## **Future Technology Devices International Ltd**

### **TN\_161 FT4222H Errata Technical Note**

**Document Reference No.: FT\_001198**

**Version 1.3**

**Figure 1 Quad SPI with Multi Write Phase**

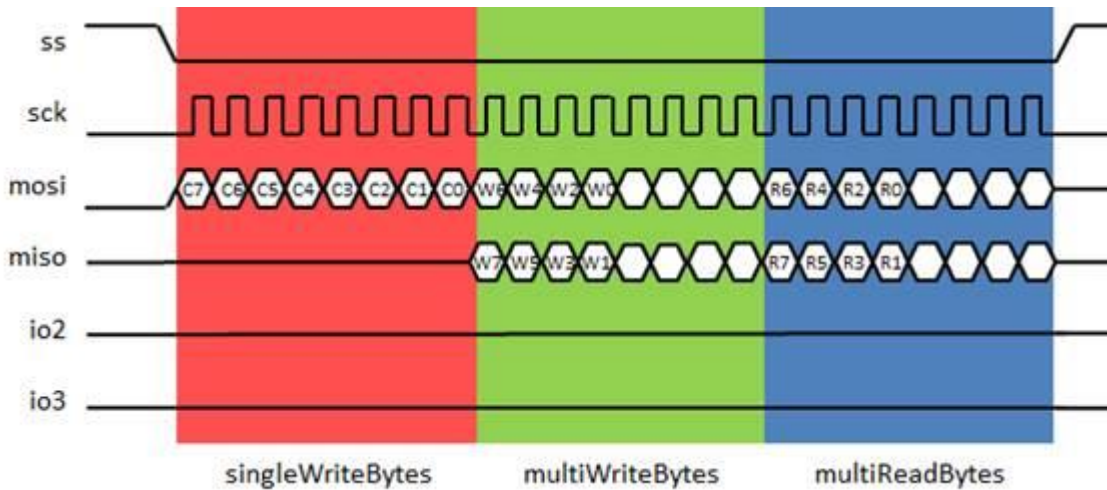
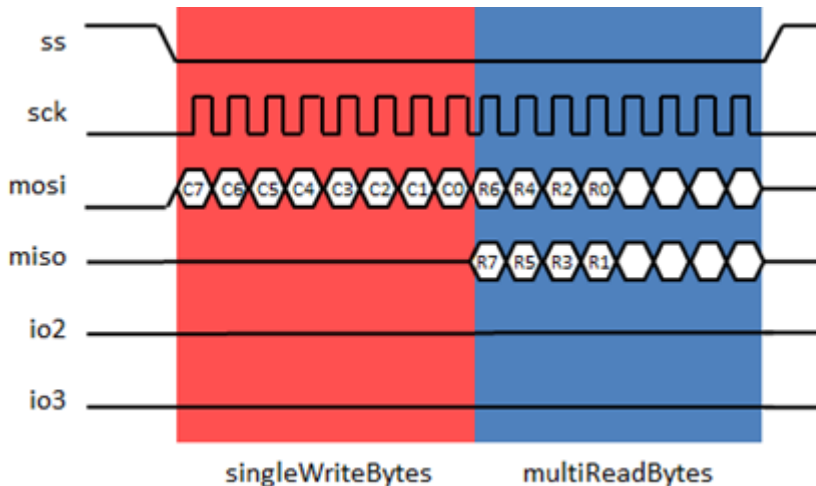
When accessing Toshiba flash with SPI Master Quad mode, FT4222H will hang without giving any responses.

FT4222H operates as master with supporting Dual or Quad SPI with three phases as illustrated in Figure 1.

As shown in Figure 1 'C', 'W' and 'R', correspond to "Command Phase", "Write Phase" and "Read Phase", where there are information/data in all three phases that are to be exchanged.

Some flash devices operate with single write and multi read protocol but without the multi write phase as illustrated in Figure 2:

Write Phase has no information/data to transfer. This combination of operating mode is not supported with Rev A, B and C.

In SPI Master Quad mode, the operation of single write with quad read was not supported. No workaround was provided, this feature is implemented with Revision D.
